## ADDENDUM NO: 02

**DATE:** 01 April 2025  
**PROJECT NO:** 119.002  
**PROJECT:** Hyde Park Elementary School  
333 East 300 North  
Hyde Park, Utah 84318  
**OWNER:** Cache County School District  
Logan, Utah

N A Y L O R  
W E N T W O R T H  
L U N D  
A R C H I T E C T S

**A1 STAIR A2 SECTION** 1/2" = 1'-0"

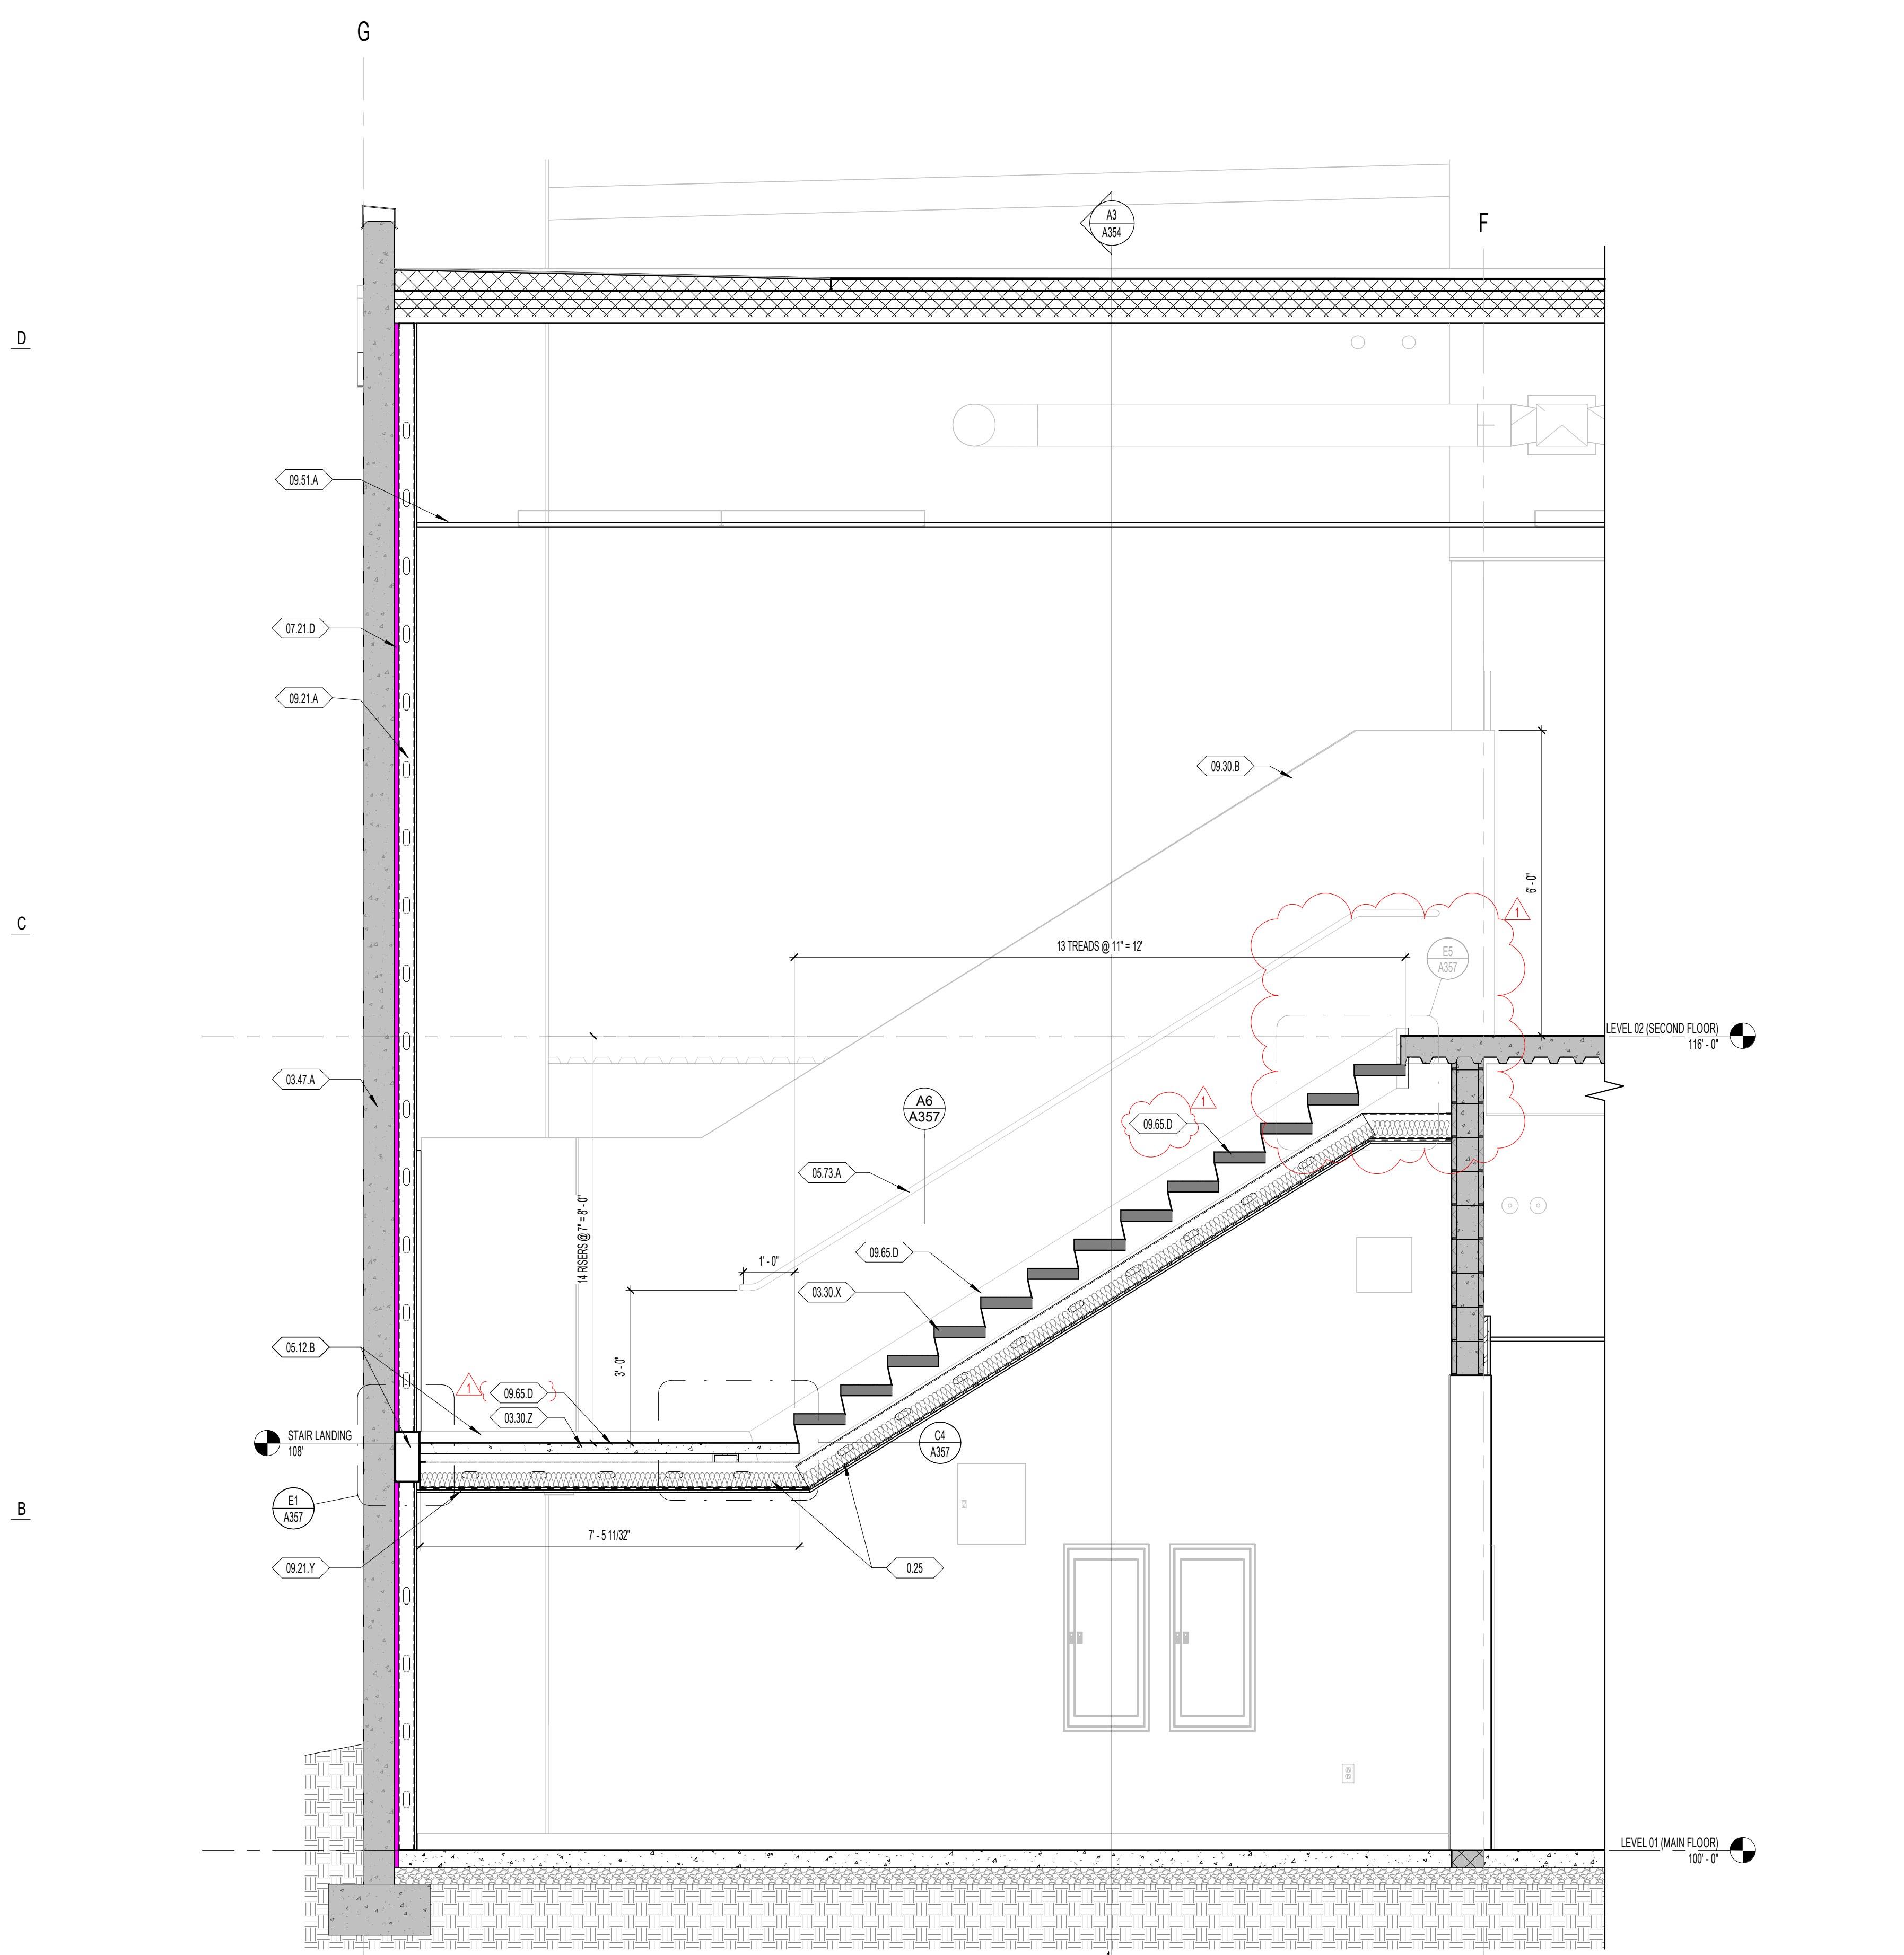
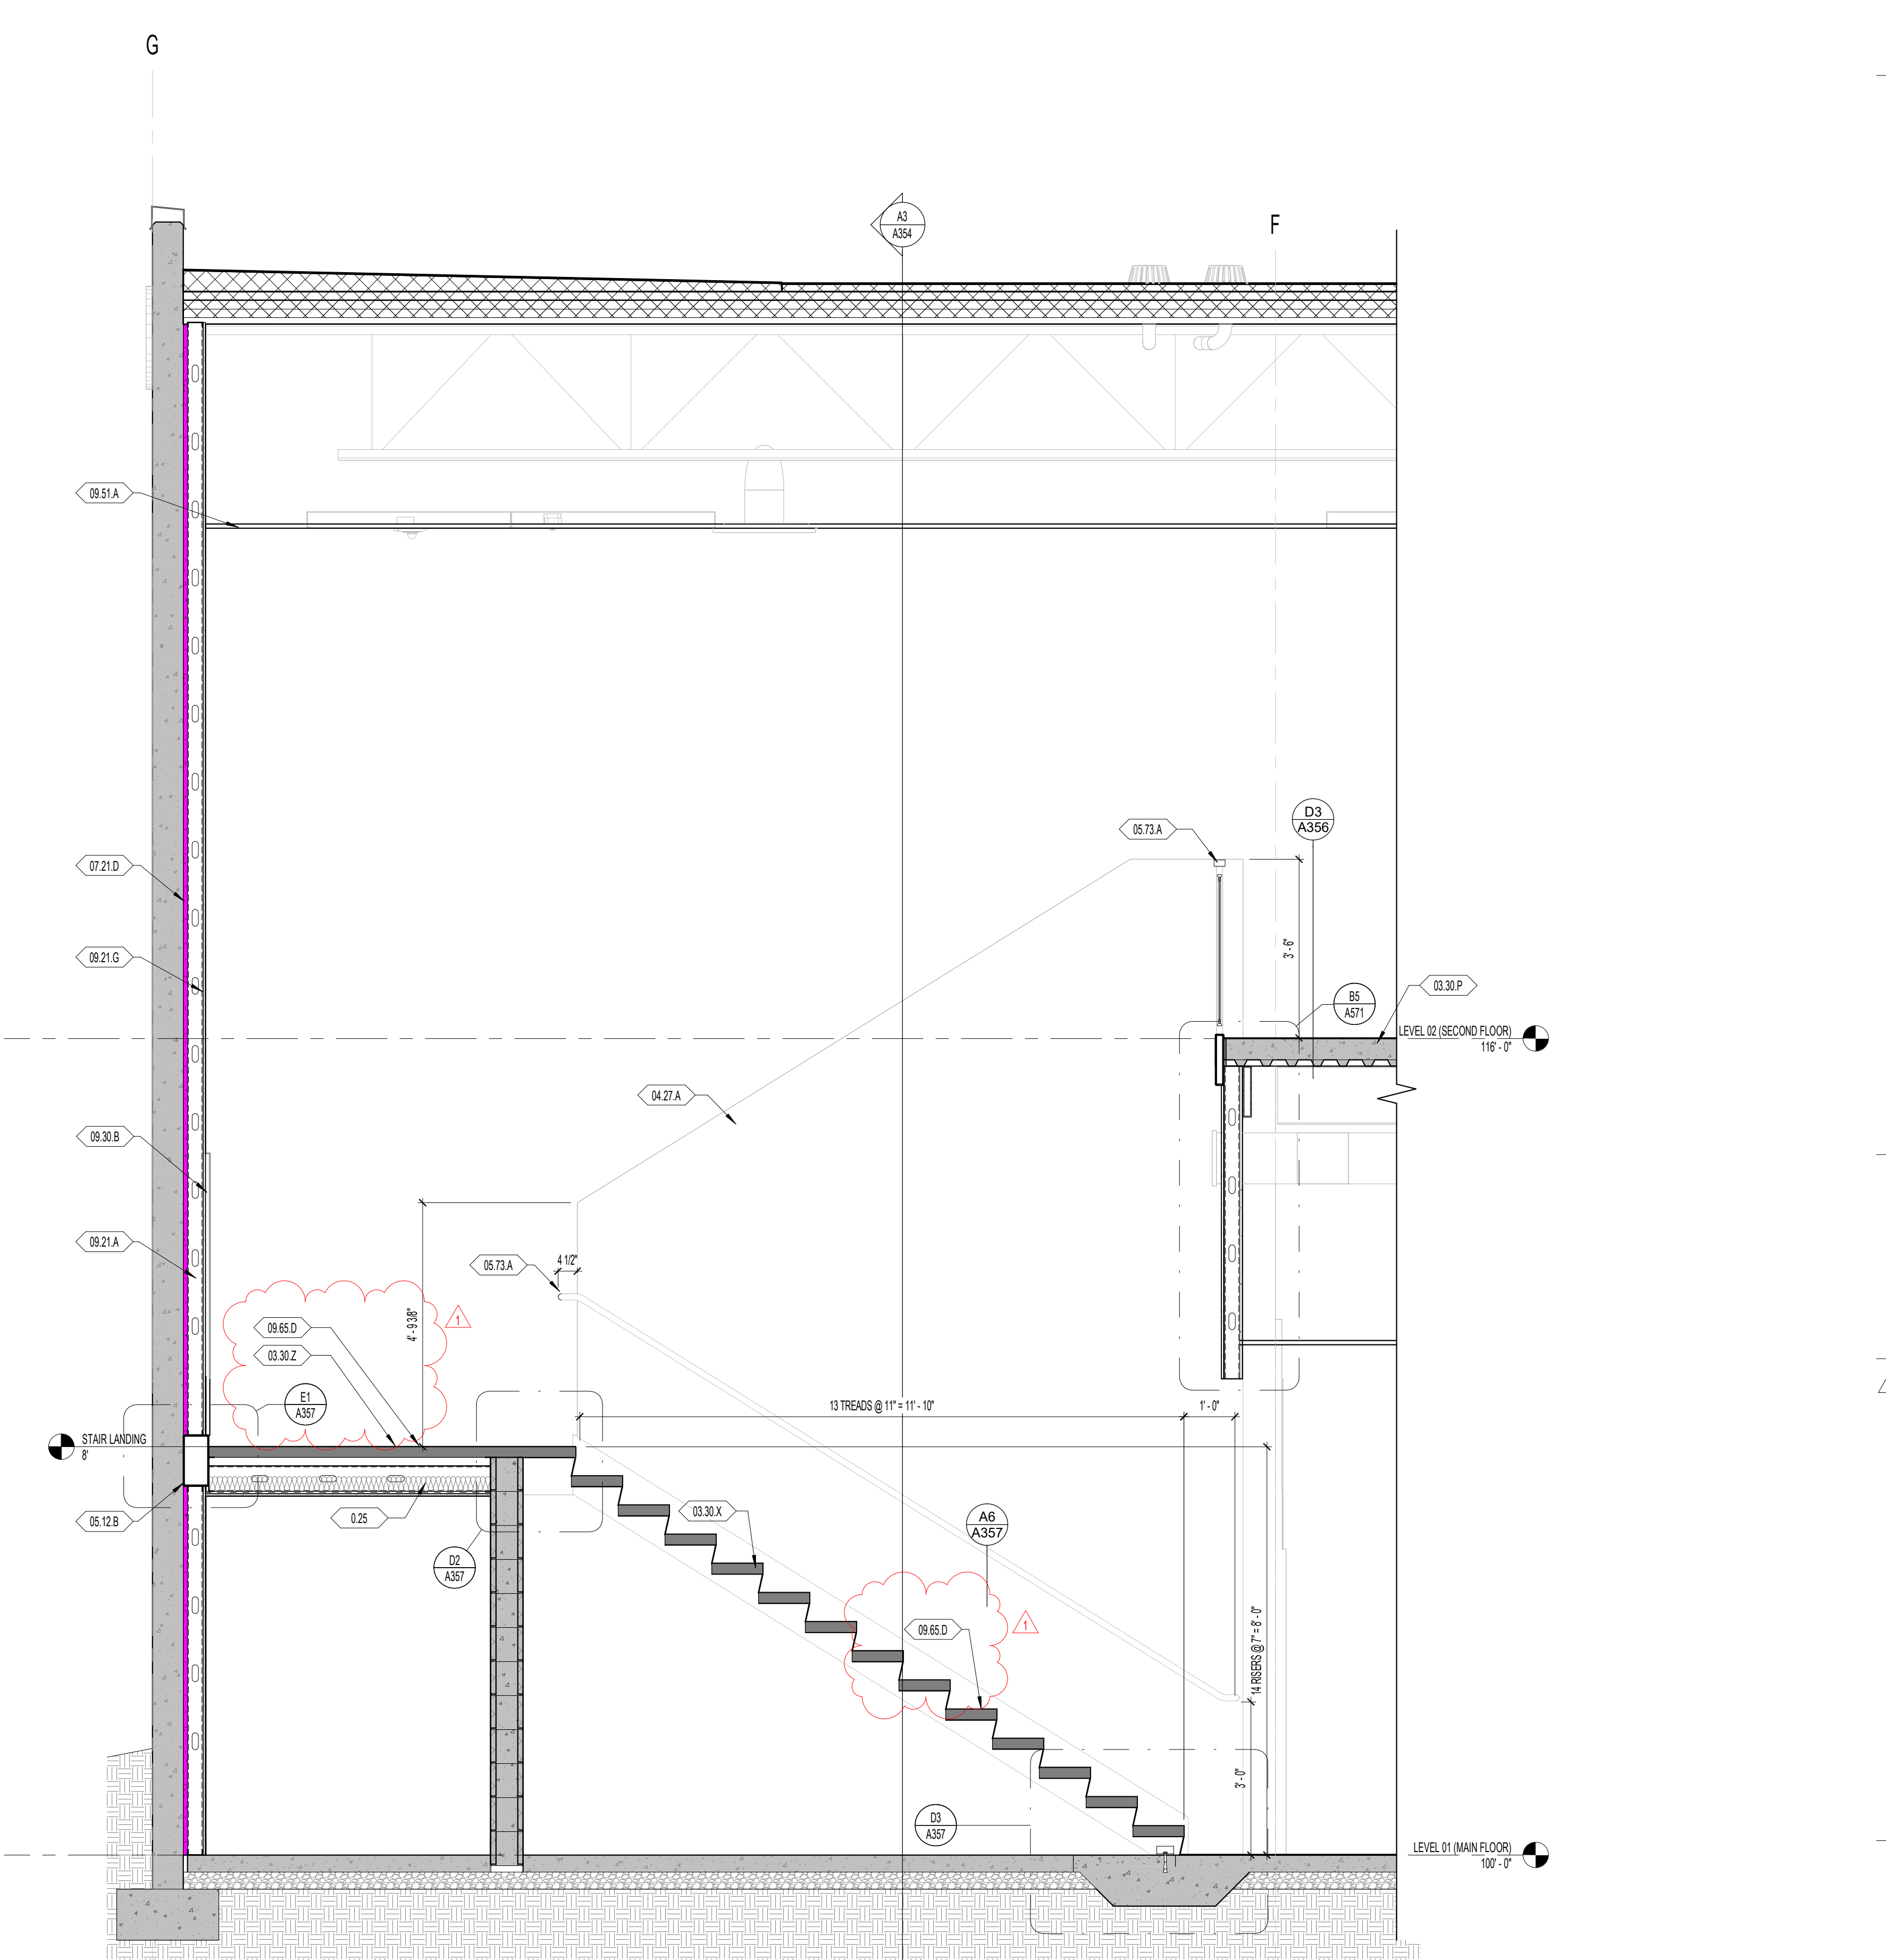
**Sheet A352 – VERTICAL CIRCULATION SECTIONS**

- Included detail E5/ A357 on section A1/ A352.
- Updated Keynote 09.65.D.
- Added keynote 09.65.D for rubber stair riser and landing on sections A1/ A352 and A5/ A352.
